Computational and Static Modeling Evaluation of CTV A1-A2 Permit Nos. R9UIC-CA6-FY21-1.1 and R9UIC-CA6-FY21-1.2

This Computational and Static Modeling Evaluation report for the proposed Carbon TerraVault 1 LLC (CTV) Elk Hills A1-A2 Class VI geologic sequestration project summarizes EPA's review of the computational modeling performed by CTV as described in the Area of Review and Corrective Action Plan (AoR CA), which is Attachment B Version 3 (submitted November 4, 2022). This report also summarizes EPA's review of the geologic narrative submitted as Attachment A Version 3 (submitted June 20, 2022) of the permit application. Clarifying questions or requests for additional information are provided below in **bold, italic** text. CTV responded to EPA's June 2023 questions about the Computational and Static Modeling on March 20, 2024. EPA's evaluation of the responses is provided in red below. Requests for revisions and additional information are presented in **red, bold and italic** text below.

Figure 3: Cross-section across the southern San Joaquin Basin showing the lateral continuity of the major formations (Zumberge, 2005).

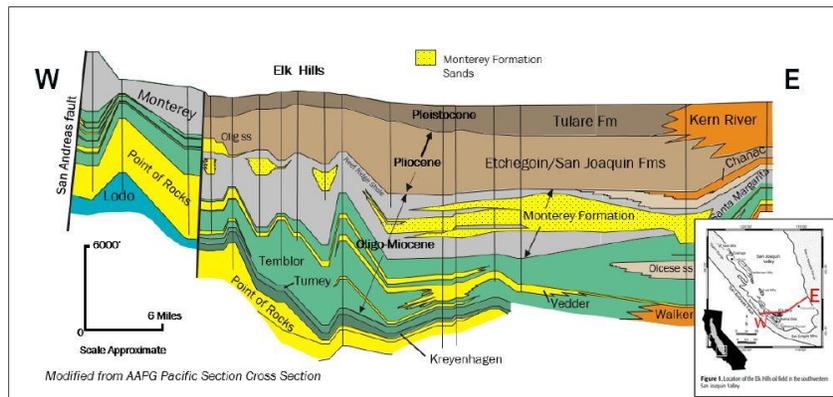
- Figure 3 in Attachment A, shown above, suggests that the Reef Ridge and Monterey Sands are time equivalent formations.
 - **Please add a description to clarify that the Reef Ridge Formation is at the very top of the Monterey Formation.**
CTV provided a description that clarified the Reef Ridge Formation is overlying the Monterey formation. No further questions.
- Page 8 of Attachment A describes the San Joaquin Formation and Etchegoin Formation.

Figure 11: EHOFF Showing location of NWS and 31S anticlines with 3-D seismic boundary and line of cross sections. (Right) Cross Section A-A' and B-B' showing structure of EHOFF anticlines with reverse faults.

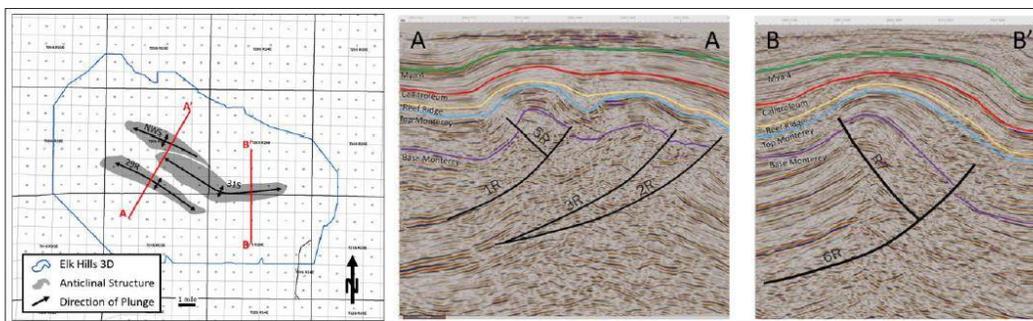
- Figure 11 in Attachment A, shown above, depicts the structure of the Elk Hills Oil Field (EHOFF) anticlines.

- **Are there any wells that could be depicted in the cross section for reference? If so, please include the wells in the figure.**
CTV stated in the response that given the scale of the section wells could not be added to the figure. CTV should at a minimum include the location of injectors and AoR on Figure 11 to inform the spatial extent of seismic cross sections provided.

- **Please include the location of the injection wells and the AoR on Figure 11.**
- **Please include a scale on the figure.**
CTV updated the figure with a scale. No further questions.

- **The A' symbol is missing from the A-A' cross section. Please indicate which side of the cross section is A'.**
CTV revised the figure to include the A' symbol. No further questions.

- **Is the sharp kink in the top of the Monterey Formation in the A-A' cross section evidence of a fault? Please include reasoning as to why or why not.**
CTV stated in their response that there is no fault at this location and the 'sharp kink' is related to the 29R structure and is a separate structure not associated with the A1-A2 or 26R reservoir, however no new data was provided in the response. In order to confirm this statement, the A1-A2 and 26R injection zones should be identified in Figure 11 of the Narrative .

- **Please include the injection zones in Figure 11 of the Narrative.**
- The seismic control of the formation is described on page 13 of Attachment A.

Figure 14: Elk Hills oil families (Zumberge, 2005).

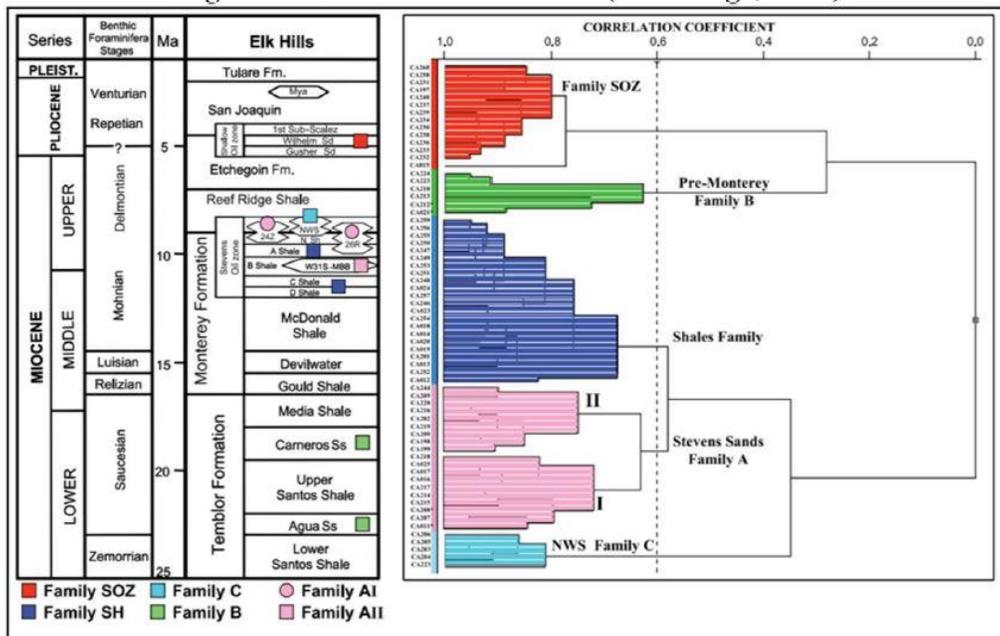
- Figure 14 in Attachment A (above) depicts the oil analysis performed in the Monterey and overlying formations.
 - **Please provide the geochemical cross-plots to identify the hydrocarbon families.**
CTV's response points to Zumberge, 2005 reference. No further questions.
 - **Please include a discussion on how the geochemical data compares to the pressure plots.**
CTV's response points to Zumberge, 2005 reference. No further questions.

Figure 19: Permeability function developed based on mercury injection capillary pressure data and calculated from log derived porosity and clay volume. Map shows the locations for wells with Monterey Formation sand core data used in the function.

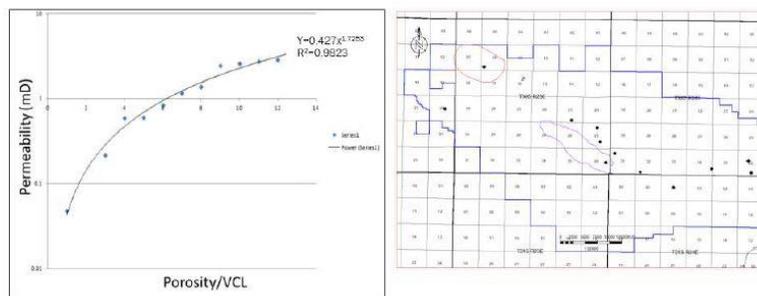
- Figure 19 in Attachment A, show above, includes a permeability curve, however there is little context, and it is difficult to interpret.

- **Does Figure 19 show an example or subset of the total data used to derive the permeability function in the figure?**
CTV addressed the comment, stating the data shown in the figure is a subset of the 13 wells and updated the figure to include well names. No further questions.

- **Please explain how the data in the figure relate to the permeability range of 3 mD to 1,500 mD and the average permeability of 45 mD?**
CTV addressed the comment by describing the range and average permeability stated are from log calculated permeability in 58 wells (131,000 data points). No further questions.

- **What location and depths were the permeability data collected from?**
CTV stated in the response that all data is from the Monterey Formation reservoir (6,000 – 9,000 vertical depth) and well names were shown on the map. 6,000 – 9,000 ft is a broad range. A table or cross section showing the sample points from 13 wells to ensure all data points were taken from A1-A2 should be provided.

- **Please provide a table or cross section showing the sample points from the 13 wells.**

Figure 20: Porosity and permeability for well 357-7R, showing the distribution and the input and output log curves.

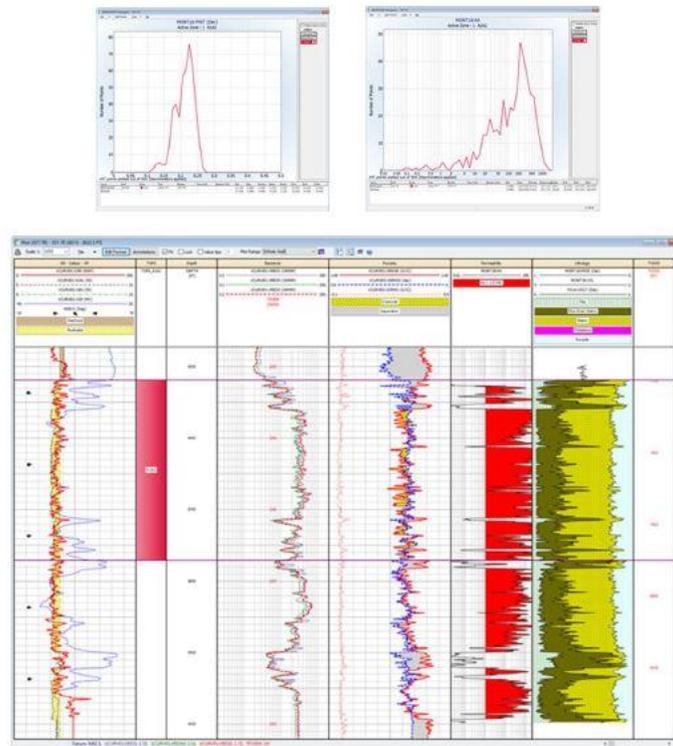
- Figure 20 in Attachment A, shown above, describes the porosity and permeability for well 357-7R. The lithology log shows no difference between the Reef Ridge Shale and the Monterey Sand.
 - **Please describe how the lithology log was created.**
CTV's response describes the clay volume (VCL) in the lithology track is calculated from a combination of the gamma ray and neutron/density separation. Figure 20 is shown as

“Figure 19” in latest version of application. It is not possible to read the well header log tracks or zonation in Figure 20 due to very low figure resolution.

- ***There are currently two figures “19”. Please correct the typo.***
- ***Please include basemap showing the 377H-26R location.***
- ***Please provide a high-resolution version of the figure.***

- ***Are the percentages of clay, fine grain matrix, matrix, and porosity very similar for the Monterey Formation and Reef Ridge Formation?***

CTV states in their response that the Monterey Formation has lower clay volumes than the Reef Ridge Shale. The permeability, track 5, shows the vast difference between the Monterey Formation reservoir and the Reef Ridge. Track 7 shows the clay volume increase from the Monterey Formation into the Reef Ridge shale. However, Track 5 of Figure 20 shows porosity, not permeability. If the very top zone is Reef Ridge, there is no Lithology track data available. Track 5 does show a low porosity material that could be representative of the Reef Ridge. See comment above for revision requests for Figure 20.

- ***Why does the lithology porosity percentage appear so similar between the two formations when the average porosity for the Monterey Formation is 21% and the average porosity for the Reef Ridge Formation is 7%?***

CTV responded that the 7% porosity was derived from the average of the MICP data. The logs are showing one interval of the Reef Ridge Formation. The permeability, track 5, shows the low permeability of the Reef Ridge Shale and the vast difference between the Monterey Formation and the Reef Ridge.

Lithology log results should be provided through the entire Reef Ridge section in both Figure 9 and Figure 20 to avoid misinterpretation of where the Reef Ridge begins on the correlation panel.

- ***Please provide lithology log results through the entire Reef Ridge section in both Figure 9 and Figure 20.***
- ***Why does Figure 9 depict 357-7R and Figure 20 depict 377H-26R? If Figure 20 is supposed to depict a different well, please update the figure.***

Figure 38: Plume modeling results showing lateral confinement of the CO₂ plume by the edges of the anticline structure.

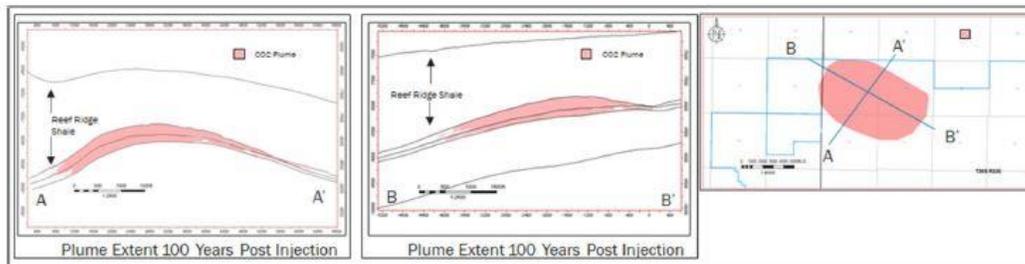
- Figure 38 in Attachment A, shown above, depicts the plume modeling results in the A1-A2 formation.
 - **Please add the injectors and monitoring wells to the figure or create a new figure to help illustrate where the penetrations in the injection zone are located with respect to the predicted CO₂ plume modeling results.**
CTV updated the application with only injection wells included on the figure. CTV should add monitoring wells, known faults and vertical exaggeration. The current binary CO₂ saturation color scheme should be replaced with a gradient or multi-color scheme in Figure 38 to clearly represent the different levels of CO₂ saturation across the figure.

- **Please add monitoring wells, known faults and vertical exaggeration to Figure 38.**
 - **Please change the color scheme in Figure 38 to a gradient or multi-color scheme to represent the different levels of CO₂ saturation across the figure.**

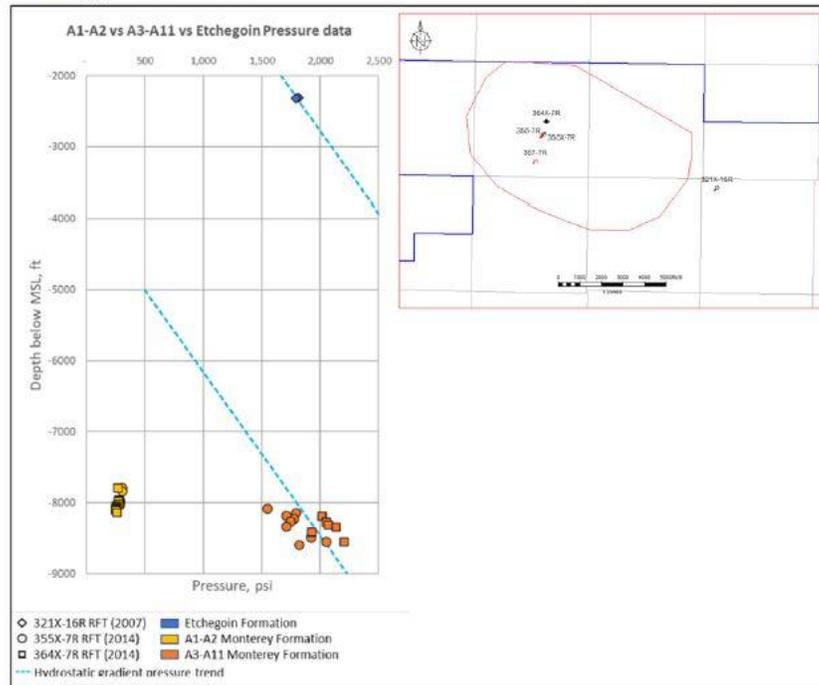
- Figure 11 in Attachment B, shown above, presents pressure data from 2007-2014 in the AoR between different formations.
 - ***This data was obtained during production operations. Is there any data representative of the initial project conditions, when production has ceased, that can demonstrate pressure isolation?***

CTV explained that the data between 2007-2014 is reflective of a period when there was limited production operations in the A1-A2 reservoir. However, pressure data of the Etchegoin at different time (such as in 2014 or after) is required to see if the pressure of the Etchegoin did not get affected by the reservoir production in A1-A2.

- ***Please provide pressure data of the Etchegoin from 2014 or after to demonstrate the Etchegoin was not affected by reservoir production.***

Figure 13: Cross-sections showing the plume development through varying times through the project.

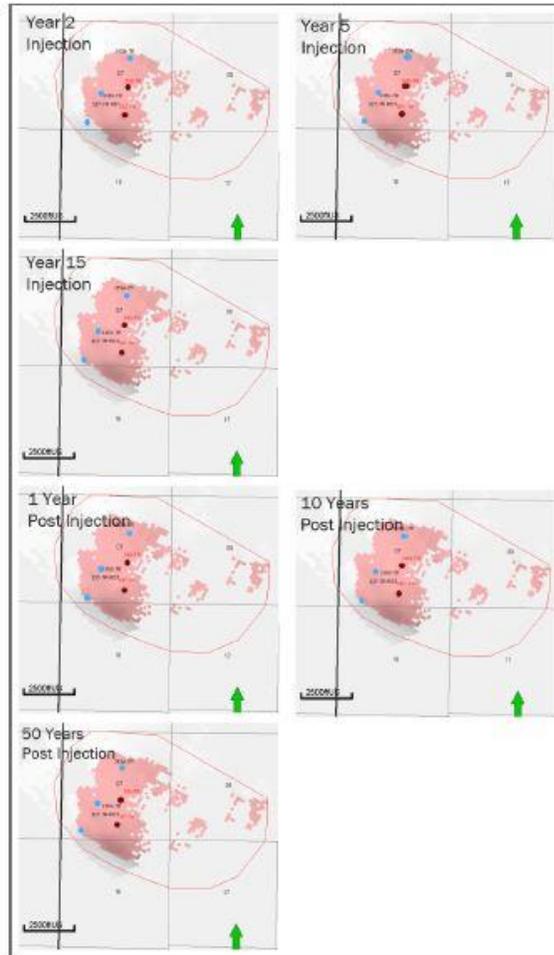
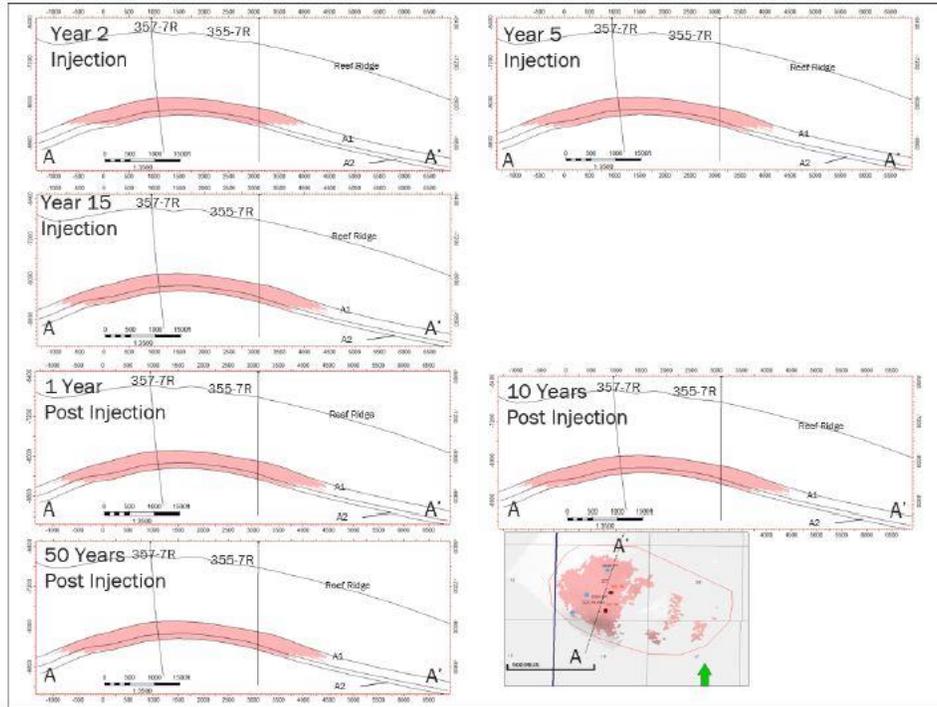
- Figures 12 and 13 in Attachment B, shown above, illustrate plume development through various times of the project.
 - ***Please display the plume results to quantitatively show the saturation. Please include cross-sectional and plan view contour plots for both gas saturation and CO₂ saturation at various times in the project timeframe. Please include figures of the simulated pressure plume over time, both in plan and cross-sectional views.***
 CTV updated the figures, but additional details are necessary for the figures.

- ***Please correct the typos in the caption.***
 - ***Please update the figure so the injectors are visible.***
- Figure 13 in Attachment B (above) depicts the CO₂ plume reaching the upper boundary of the model.

- ***Please explain how the spatial extent of the model is sufficient if the CO₂ plume reaches the boundaries.***
 CTV states in the response that the CO₂ plume does not reach the lateral boundaries, but does reach the upper boundary and that since the upper boundary (Reef Ridge Formation) is a no-flow boundary the spatial extent is sufficient. However, the lateral extent size affects both the CO₂ plume and pressure front. Although CO₂ does not reach lateral boundaries, pressure may. The small model size may affect pressure change which could affect fluid dynamics within the model.

- ***Please explain and provide justification for why the lateral extent size is large enough for the pressure front.***

- ***Please explain how no-flow boundary conditions are appropriate if the CO₂ plume reaches the boundaries.***
 CTV explains in the response that the upper vertical boundary of the model is the very low permeability Reef Ridge shale, which is the confining zone for the reservoir and although the CO₂ plume does not reach the lateral extents of the model, they are considered closed due to the production history of the reservoir which indicates a closed reservoir with no external pressure or aquifer extent. However, closed boundary conditions are about transport of fluid component across the boundary, not pressure. CTV should describe the pressure conditions due to injection at the lateral boundary.

Figure 7: Monterey Formation A1-A2 sands porosity and permeability distribution in the static model.

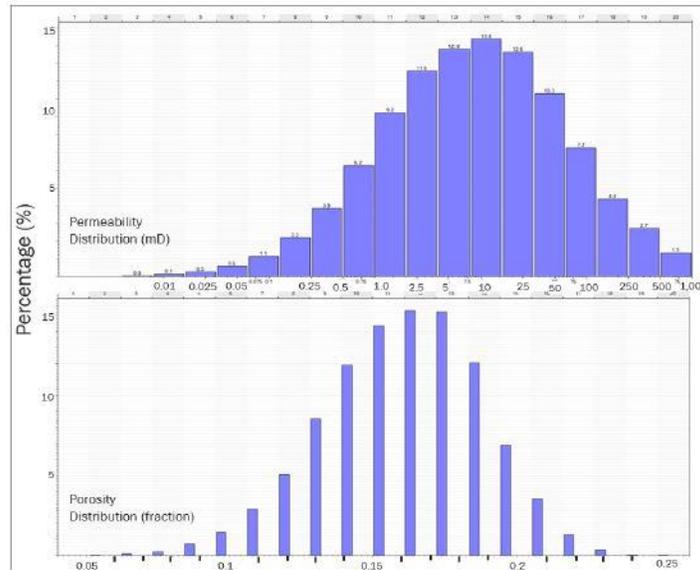
- Figure 7 in Attachment B shows porosity and permeability histograms for the Monterey Formation.
 - ***Please provide additional data (open-hole well log analysis) or other measured data that can be used to verify the permeability and porosity used in the static model.***
 No new data provided in application material. Attachment B would benefit from a map showing wells used in the model in addition to open-hole well log analysis as previously requested (well correlation windows showing raw vs. upscaled data, histograms showing raw vs. upscaled data, for example).

- ***Please include a figure that shows the locations of wells that had data included in the model.***
 - ***Please include additional data (open-hole well log analysis) or other data (e.g. well correlation windows showing raw vs. upscaled data, histograms showing raw vs. upscaled data) to verify the permeability and porosity data used in the static model.***

Figure 8: Sections through the static grid showing the distribution of porosity and permeability in the reservoir.

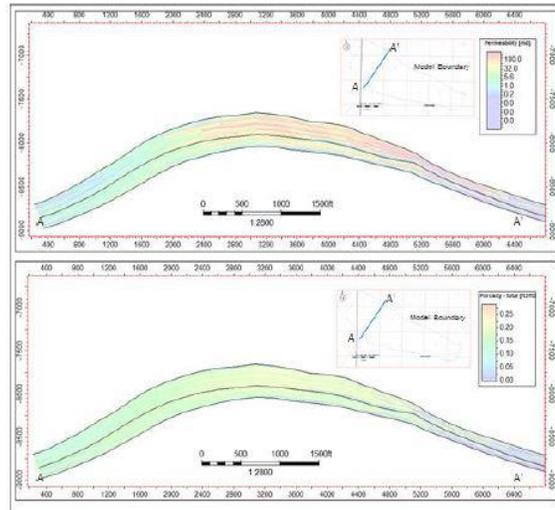
- Figure 8 in Attachment B shows the distribution of porosity and permeability of the reservoir at cross section A-A.
 - **Additional visuals would help confirm the reservoir properties. Please provide a similar figure from a different cross section.**
 CTV provided an additional section to Figure 8 in attachment B. Figure 8 would greatly benefit from being higher resolution to see the AoR outline in basemaps.
 - **Please provide a higher resolution version of Figure 8.**

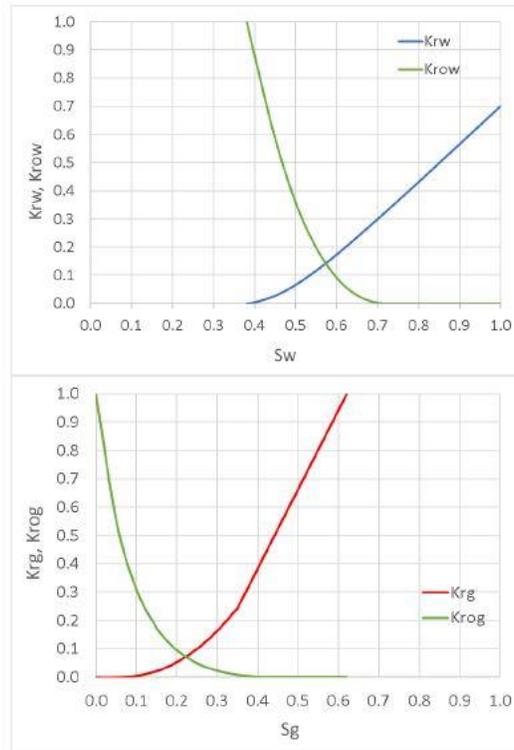
- Figure 9 in Attachment B shows the relative permeability curves used in the computational modeling.
 - **Please provide the functional forms that were used to create the curves shown.**
CTV explained in the response the functional forms used to create Figure 9, however Figure 9 is not included in the updated version of Attachment B.
 - **Please include Figure 9 in Attachment B, list the functions and their parameters in the narrative, and ensure that the plotted k-S-p relations are consistent with what was used in the model.**
 - **Please include the data used to create the curves in a tabular form.**
CTV states in the response Relative permeability data from wells 367-7R and 345A-36R are presented in tabular form in Figure 9 in Att-B, Pg 11, however Figure 9 is missing in the latest version of Attachment B, see comment above.

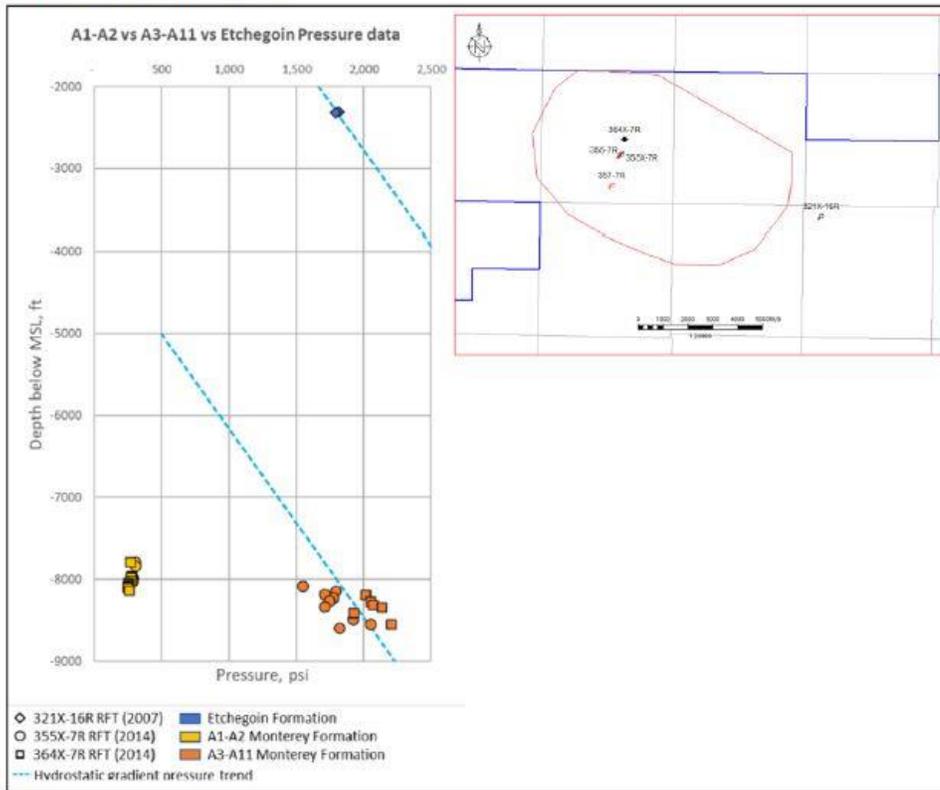
- Figure 11 in Attachment B pressure data from 2014 for the A1-A2 and A3-A11 reservoirs are shown.
 - Pressure measured at different times is needed to assure there is no migration. ***Is there any measured pressure data over different times? If so, please provide it.*** CTV referred to Figure 14 in the response which includes pressure data for multiple wells. However, pressure data is needed for the same well at different times to see the impact of the production on the reservoir and confirm the isolation.

- ***Please provide pressure data from the same well during production and after production to confirm isolation.***
 - Pressure in the Etchegoin Formation and A3-A11 reservoir is the same even though the y-axis shows their depth is very different. ***Please provide an explanation. If production from the A3-A11 reservoir resulted in pressure depletion, please include that in the explanation.*** CTV stated in their response that the A3-A11 reservoir has been produced from since 1973. No further questions.
